From: [EPConsultations](#)
To: [MD Marine Renewables](#)
Subject: RE: Green Volt Offshore Wind Farm - Additional Information Application Consultation - Response required by 18 December 2023
Date: 20 December 2023 17:00:50
Attachments: [image001.png](#)
[image002.png](#)
[image006.png](#)
[image007.png](#)
[image008.png](#)
[image009.png](#)
[image010.png](#)
[image003.png](#)
[image005.png](#)

Green Volt Offshore Wind Farm Ltd – Section 36 Application

Representation by Caledonia Offshore Wind Farm

[The Marine Works \(Environmental Impact Assessment\) \(Scotland\) Regulations 2017
Green Volt Offshore Wind Farm - Additional Information Application Consultation](#)

Figure 2.2 Preliminary arrangement of turbines and substructure at Green Volt Project Area.

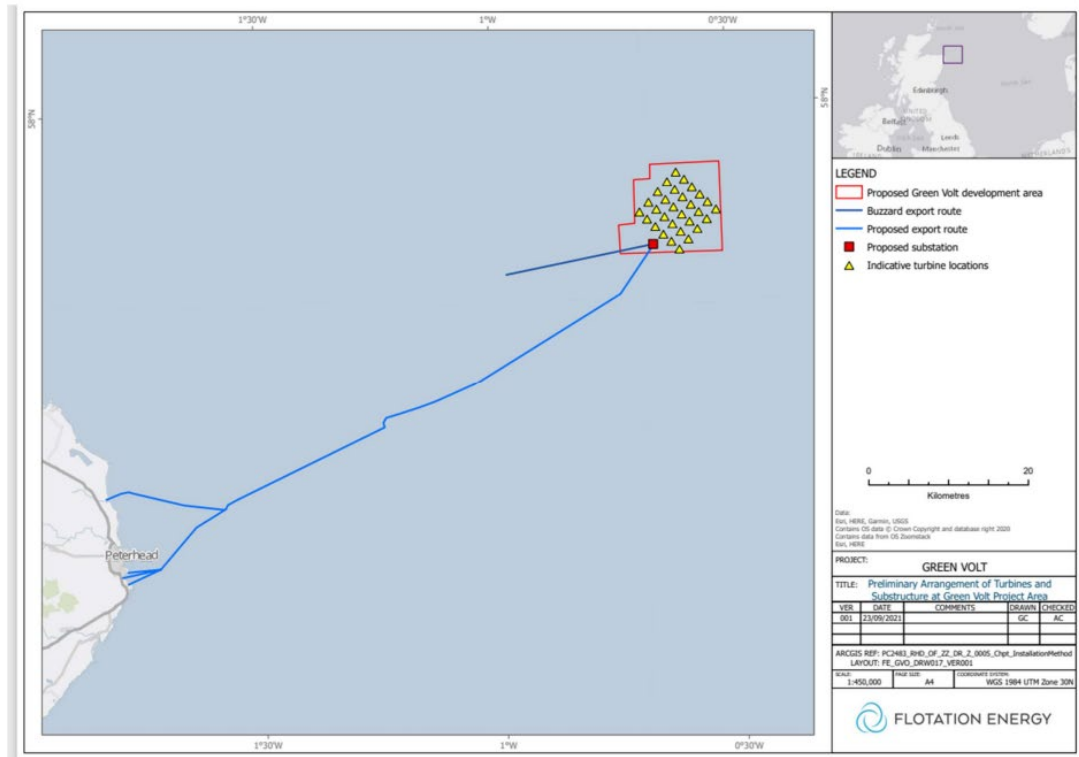
We requested turbine / development area NGR coordinates on 7/11/23 and as yet have had no response.

Without coordinates we cannot make a detailed analysis, however based on the image provided to us (above), this proposal is **cleared** with respect to radio link infrastructure operated by the local energy networks.
